Report to Planning and Environment Committee

Subject: 2492222 Ontario Inc.
536 and 542 Windermere Road

Public Participation Meeting on: April 15, 2019

Figure 3: Revised Conceptual Site Plan

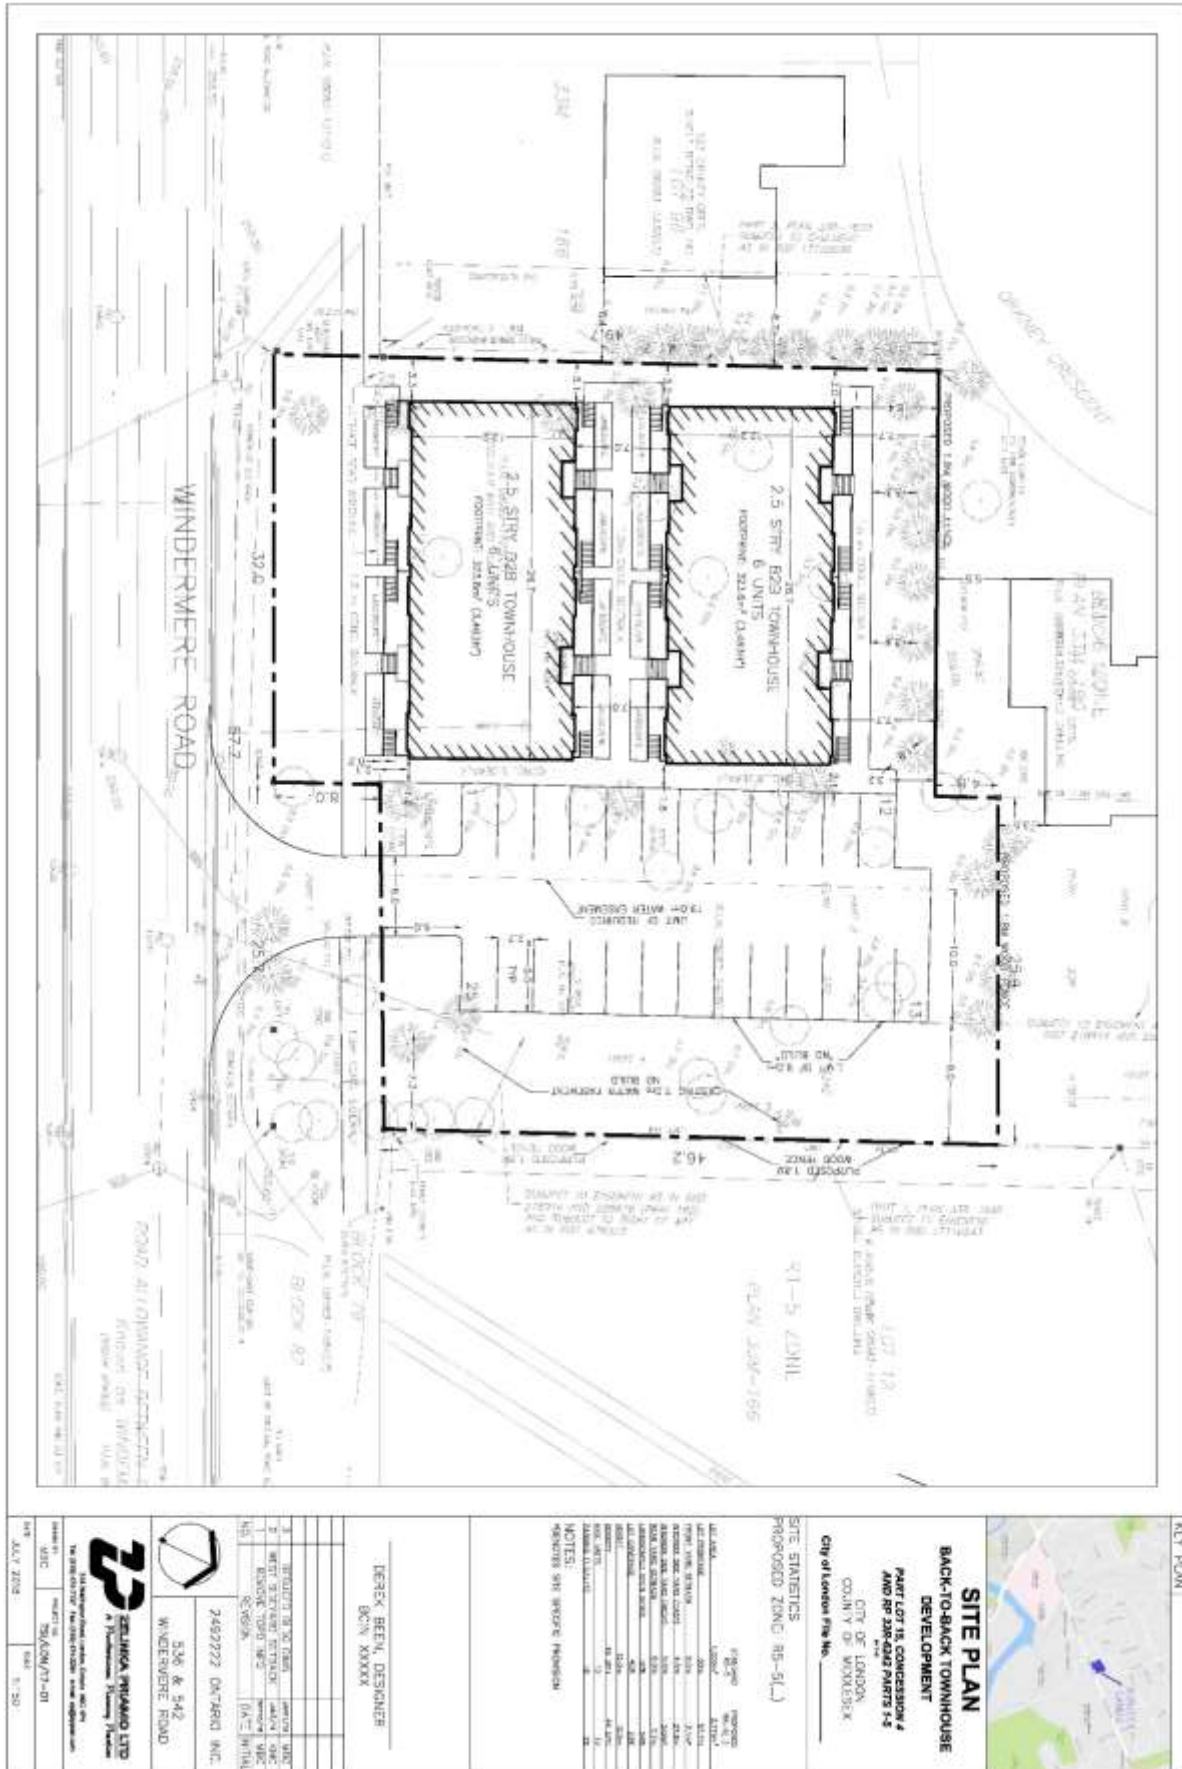
- It appears that the building has been moved an additional 1.7m further from the northern property line, based on a new rear yard setback of 7.7m, indicated on the revised site plan provided. This 7.7m separation distance does not include the lowered amenity spaces extending an additional 1.9m, nor 1.5m for the surfaced sidewalk. It also does not include the extra space that will be required for landscaping in front of each of the lowered amenity spaces - as per London's site plan approval requirements, and as indicated on the application's revised site plan for the amenity spaces between the two buildings which appear to be approximately 1m each. Based on the revised 7.7m setback (to the building face), the net separating distance TO THE PROPERTY LINE would be approximately 3.3m. The existing trees range from 1-2m from the property line to their trunk. Their trucks extend as much as 0.5m. The drip line for the majority of these trees extend beyond 3m from their trunk, with some extending as much as 4.5m.

- Based on this simple math, it still appears that the revised designed submitted by the applicant still fails to provide sufficient separation from these existing trees in order to protect and retain them during construction. So how, if the city planning staff have done their proper due diligence, can you support and recommend the revised applicant as currently submitted? Again, this does not meet the directions provided by the PEC in January. It is not acceptable and will be challenged

Hi. A 7 foot front yard to the now normal setback is way to small. Nothing on Windermere is that close. For ever it will look out of place and not at all conforming to the normal. This is not good business practise. This is still WRONG, why is the City even considering such a mistake, that can never be correct, if allowed! ...Bob and Ellen Barker

Figure 3: Revised Tree Preservation Plan (March 2019)

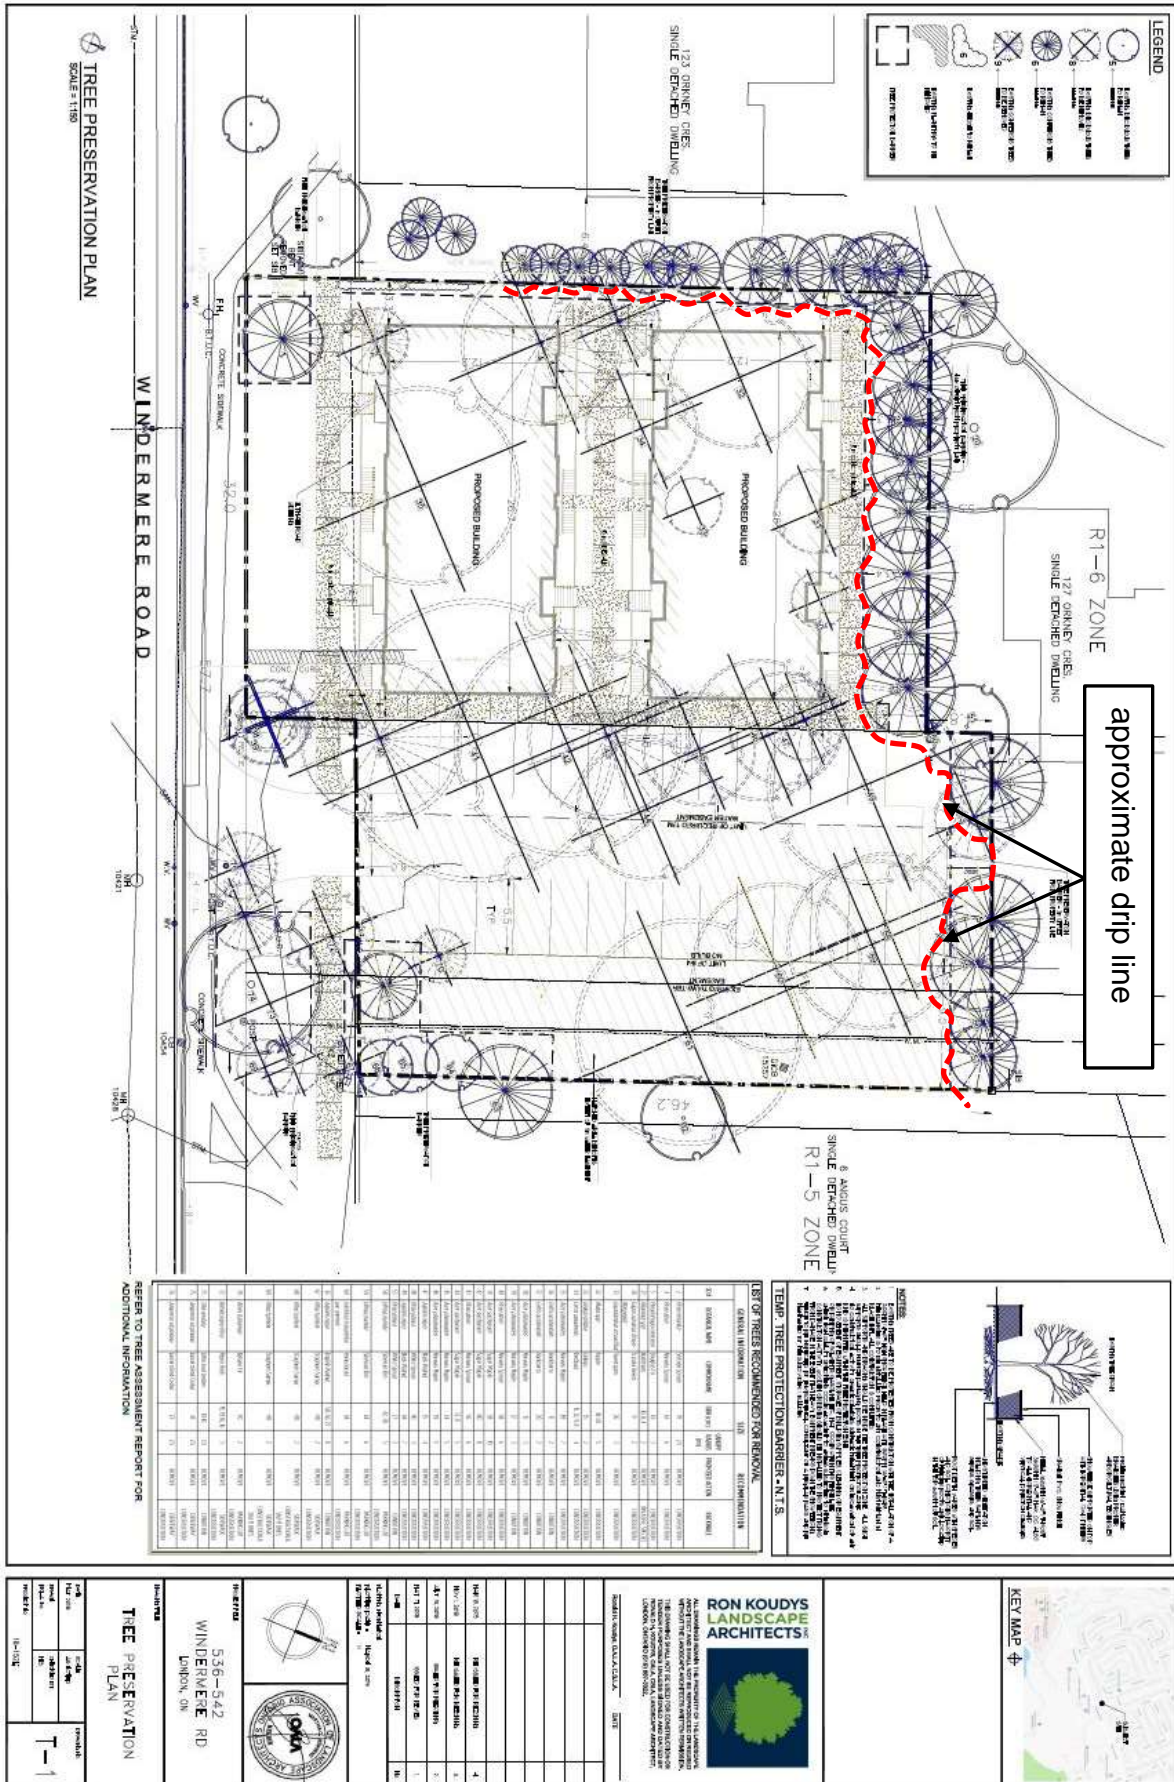
- 1.) The temporary fence in the written portion of the tree preservation document does not clearly state a 'no dig, no cover' specification. 'No dig, no cover' is implied but it is not clearly stated. The 'no dig, no cover' has to be extended to the future after the initial construction is complete and the temporary fence is removed. This needs stronger wording such that there is no misunderstandings. An easement would be a good way to preserve this area and keep it natural. I believe the PEC members understood that the tree preservation plan would be created by an impartial arborist, not one in the employ of the developer, in order to eliminate any bias or weak content.

- 2.) The diagram and measurements on the site plan are inaccurate because they do not show the actual extent of the drip line. The drip line of the trees at the back of the building (trees 22, 23, 24, 25, 26, 27, 28 and 29) extend 5.8 meters from the fence / 4.5 meters from the tree stem. The drip line as shown on the tree preservation plan is grossly understated. The temporary fence needs to be moved further away from the trees such that the temporary fence is 5.8 meters from the property line. As currently shown on the site plan, the branches if not cut, would be rubbing up against the side of the building. This current plan will cause too much damage to the tree roots and branches as well as too much shading. Similarly, the temporary fence distance from the property line for trees 52, 54, 55, 56, and 57 is inadequate. The actual drip line for these trees extends 4.2 meters from the fence line and needs to be extended to 4.2 meters from the property line. It is clear that the developer has minimized the size of these trees. The PEC meeting in January stated clearly that the building had to be reduced in size to fit within the R5-5 boundary side lot and back lot setbacks. This building is still too large for the site and infringes upon the trees' living space. It is clear that the trees need more root protection space and more protection from shading.

- 3.) The odd shaped piece of curb and sidewalk infringes too far into the root zone of tree #29. This odd shaped piece will have to be removed from the plan. This protrusion also impacts item 5 below (drainage).

- 4.) The trees along the west lot line on the adjacent property are not addressed at all. The PEC was very clear that these trees were to be included in the tree preservation plan. Here too the building encroaches into the trees' space both from a shading and root protection perspective. The PEC directive stated that the side lot distance from the building was to be 0.5 meters per meter of height (or fraction thereof). This side lot distance from the building to the side lot needs to be 5.5 meters. The temporary fence needs to be moved out to 2.3 meters from the side lot property line. The building needs to be reduced in size to fit this criteria and the tree preservation plan requires updating to include the westerly trees.

- 5.) There are just a few general sentences about the existing drainage patterns. There is no plan whatsoever about how these drainage patterns are to be maintained. A water retention and drainage plan needs to be defined in detail. The area at the back of these properties is a water collection area for rainwater runoff and snow melt. I have seen years when the spring water is three feet deep. The spring water saturation of the soil at the back of the property is essential for the ongoing health of the larger trees. The tree preservation plan does not address this at all. The two parking spaces closest to rear property line need to be removed in order to maintain the saturation zone for the trees along the back of the property as well as an increased protection zone as stated in #2 above (increase to 4.2 meters).

Tree preservation and fencing are notably matters for Site Plan Approval (“SPA”) and will be coordinated through the SPA process. Staff, in response to the direction of Council, have reviewed the revised tree preservation plan (March 2019) and the revised tree assessment report (March 2019) for consistency with best practices for tree preservation as discussed below in detail. The revised conceptual site plan (January 2019) indicates that a 1.8 metre high board-on-board privacy fence would be provided along the northerly, easterly and westerly property lines. Yard depths as well as separation distances are also discussed below, and some changes to yard depths and separation distances were achieved and are shown on the revised conceptual site plan. Should the PEC and/or Council want to consider and proceed with a zone change that reflects all of the specific yard depths identified in the January 15th, 2019 Council Resolution, an alternative by-law has been attached to this report as Appendix “B”. For a complete planning analysis regarding the zone change application for the subject lands, the January 7th, 2019 report to the PEC should also be reviewed and is attached as Appendix “D” to this report.
